Staff Comments:

Planning and Development Comments as of February 24, 2020:

DRAPER LAKE OVERALL SITE PLAN

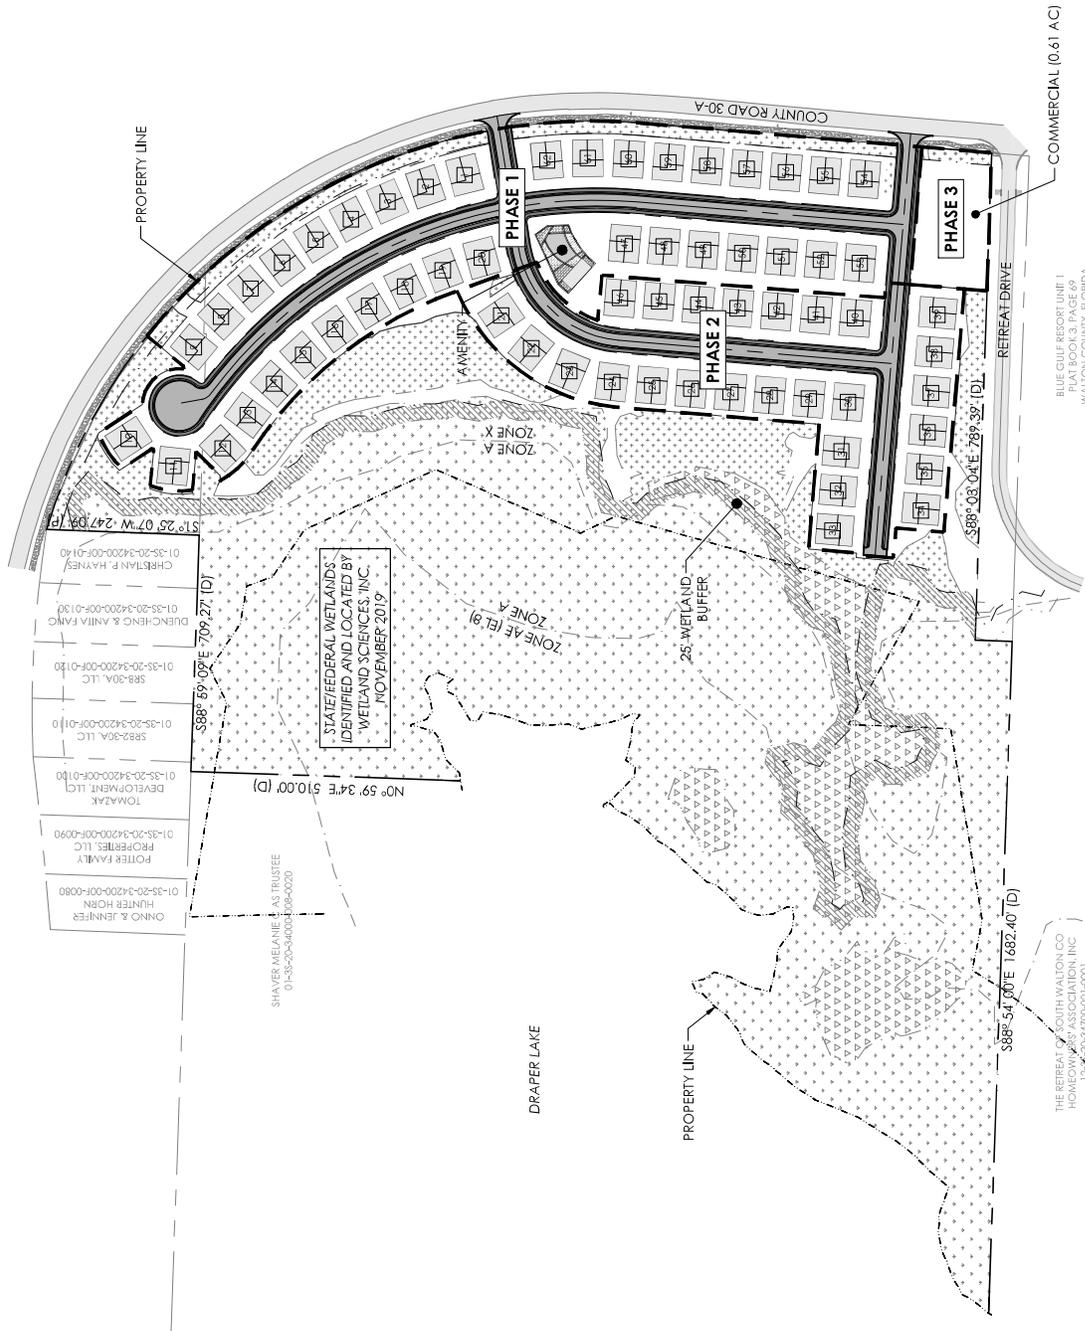
1. Please include the term "Conceptual" on the proposed conceptual plan.
2. Please ensure that all uses are labeled on Sheet A1.
3. Section 2.06.02(A)(3) requires building heights to be identified within the conceptual plan submittal. Less than maximum is not sufficient.

4. Open space is "the amount of the site that is devoted to recreation, resource protection, amenity, and/or landscaped buffers." Sheet A3 identifies the space between the proposed structures as open space. These areas are not devoted to recreation, resource protection, amenity, or landscape buffers. Please correct the labeling and area calculations regarding the open space component of the concept plan.

5. Please identify all required buffers. Please identify the width of all buffers on the conceptual plan.
6. Please ensure all portions of the PUD documents and Conceptual Plan coincide with one another. The Plan identifies a 6,000sqft commercial space, as do some portions of the documents. However, there are other areas of the document that indicate the commercial space will be determined during the technical phase. The Code requires parking space counts and ratios for each land use during conceptual plan review, if 6,000 is being proposed conceptually, please ensure that all portions of the plan and documents agree. (See comments relating to the area of the commercial component in subsection B.)

7. Please provide the required parking for the pool amenity. Identify this area within the Conceptual Plan.
8. Please provide the projected timeframes for the various development phases as identified within the Conceptual Plan.

4. The Small Neighborhood zoning district requires 5% of the development project area be devoted to commercial uses. The development project area is 36.66+/- acres, not 12.14 acres. Developable area should not be considered an expression in the calculation. Please address the required commercial area within the Conceptual Plan and PUD documentation to include all applicable calculations/ratios and plan sheets.

8. Consider alternative street alignment with Retreat Drive.
9. Consider a more Urban design with vertical mixed-use structures adjacent to 30A.
10. Ensure that all figures, ratios, areas as identified in the conceptual plan and documentation agree, i.e., the commercial area, is it 0.61, 0.56, or 0.55 acres? If the difference in this particular instance is related to the scrub habitat, please include a statement indicating as much when the figures do not align.
